Statement of Response to LRD Opinion

**Prepared in Respect of a Planning
Application for a Large-Scale Residential
Development at a Site in the Townlands
of Glenamuck North, Kilternan, Dublin 18
(Northern Site)**

**On Behalf of Durkan Carrickmines
Developments Limited**

Figure 2.3: Indicative Outline of the Subject Site (in Blue) and the Western Site (in Pink) within SDF3 (Indicative Outlines Only)

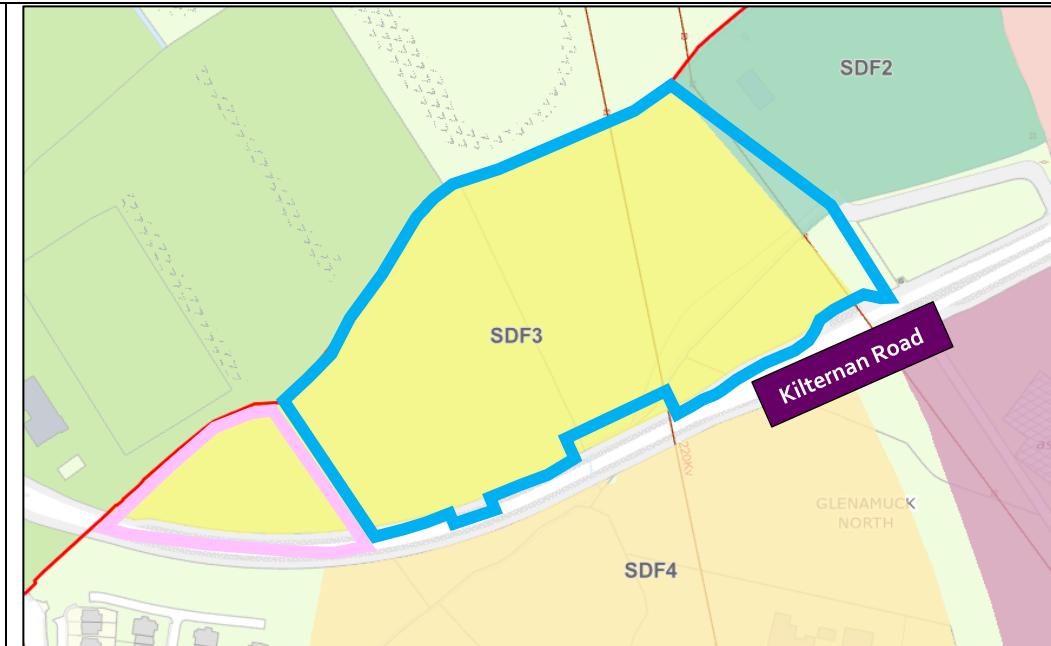
<p>2. <u>Vehicular Access from the Kiltiernan Road Required in the Kiltiernan-Glenamuck Local Area Plan 2025</u></p> <p>The subject site is identified within Site Development Framework No. 3 (SDF3) in the recently adopted <i>Kiltiernan-Glenamuck Local Area Plan 2025</i> ('LAP'). We note that the provision of a vehicular access to the site via the Kiltiernan Road is required under the following Objective of the LAP:</p> <p style="padding-left: 40px;"><i>"Vehicular access to the land parcel will be via one access from the Kiltiernan Road unless otherwise agreed with the Local Authority."</i></p> <p>As illustrated in Figure 2.3, SDF3 comprises two sites: the subject site and a smaller, undeveloped site to the west which is not under the control of the Applicant. We understand that development has not come forth yet for the lands to the west of the site and thus the only possible access to the subject site would be directly from the Kiltiernan Road. However, we note that proposed layout facilitates the infrastructure associated with a vehicular and pedestrian link up to the western boundary and any future development of these western lands will be able to continue the infrastructure into the site. This ensures the development to the west will be facilitated with access to the Kiltiernan Road via the subject site.</p>

Figure 2.4: Existing Site Plan (Outlined in Red) with the Vehicular Access Restrictions Identified

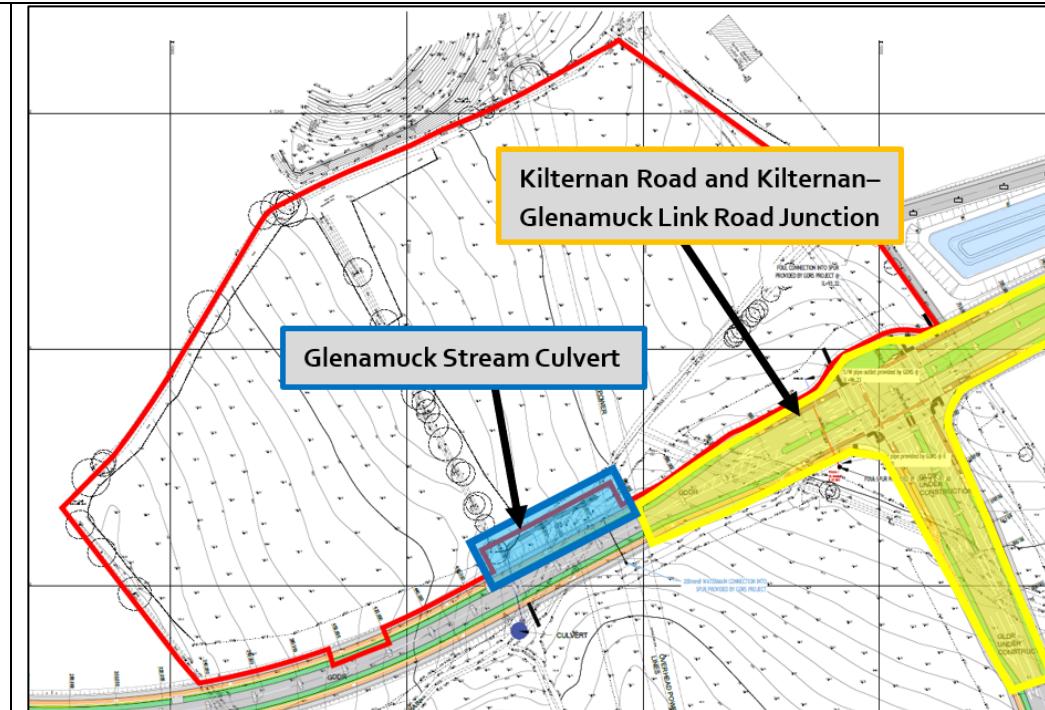
<p>2. Vehicular access onto GDRS scheme: The Applicant will be required to submit a detailed justification for the location and design of the proposed vehicular onto the GDDR. The proposed layout shall also be subject to a detailed Road Safety Audit.</p> <p>All potential impacts to the GDRS scheme and existing local road network shall be assessed in detail by way of a Traffic Impact Assessment which shall include for relevant committed developments.</p>	<p>The location of the proposed vehicular access point to the site from the Kilternan Road has been thoroughly considered by the Applicant and Design Team having regard to the following:</p> <p>1. <i>Junction Envisaged in the GDRS Application</i></p> <p>An indicative location of an access to the subject site was identified as part of the Glenamuck Distributor Roads Scheme (GDRS) application (ACP Reg. Ref. HAo6D.303945), as illustrated in Figure 2.2 below.</p>  <p>Figure 2.2: Future Junction Access at the Subject Site Envisioned in the GDRS</p> <p>(Source: As Submitted Under ACP Ref. HAo6D.303945, Annotated by Thornton O'Connor Town Planning, 2026)</p>

<p>The location of the Kilternan Road culvert along the southern boundary of the site is approximately halfway along the boundary, as illustrated in Figure 2.4. Given no works can be carried out to this culvert (as the culvert is required as part of the GDRS), a central portion of the site's southern boundary along the Kilternan Road is thus restricted from providing access to the site.</p> <p>4. <u>Proximity to the Kilternan Road and Kilternan–Glenamuck Link Road</u></p> <p>The junction of where the Kilternan Road and Kilternan–Glenamuck Link Road meet is located to the south-east of the subject site, with the junction layout extending across approximately half of the site's southern boundary, as illustrated in Figure 2.4. This junction restricts the provision of an access point to the site along the eastern part of the southern boundary.</p> <p>5. <u>Proposed Vehicular Access</u></p> <p>The restrictions posed by the Glenamuck Stream culvert along the site's boundary and the Kilternan Road and Kilternan–Glenamuck Link Road junction layout relative to the site's boundary are outlined on the existing site layout plan provided in Figure 2.4.</p>

<p>Figure 2.6: Location and Layout of the Future Connection Link to Jamestown Park (Source: Drawing No. 'L1_100_1' by NMP, Annotated by Thornton O'Connor Town Planning, 2026)</p>

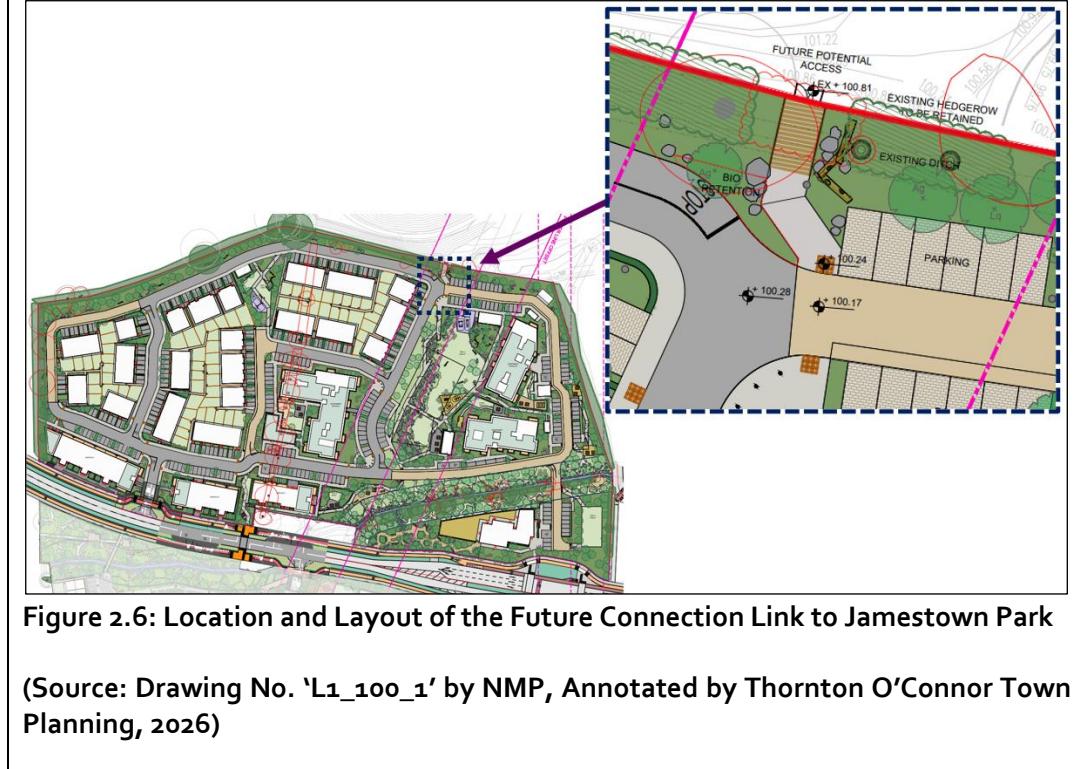
5.	<p>In conjunction with Item 1 above, the Applicant is requested to provide details on how the proposed scheme can be linked to the planned Jamestown Park (notwithstanding relevant consents and future development) by way of a pedestrian/cyclist connection on the northeastern corner of the site. There is an expectation that this would link would form part of the application at Stage 3. The Movement Objectives of SDF3 of the LAP refer to this matter.</p>	<p>A future connection point is identified along the northern boundary of the site to connect into the future Jamestown Park to the north, as illustrated in Figure 2.6. The proposed layout facilitates the infrastructure associated with a pedestrian link right up to the northern boundary, however, as the proposed development does not physically connect into the lands and given there is no existing development to connect into, in our opinion, no Letter of Consent from the adjoining landowner is required.</p>
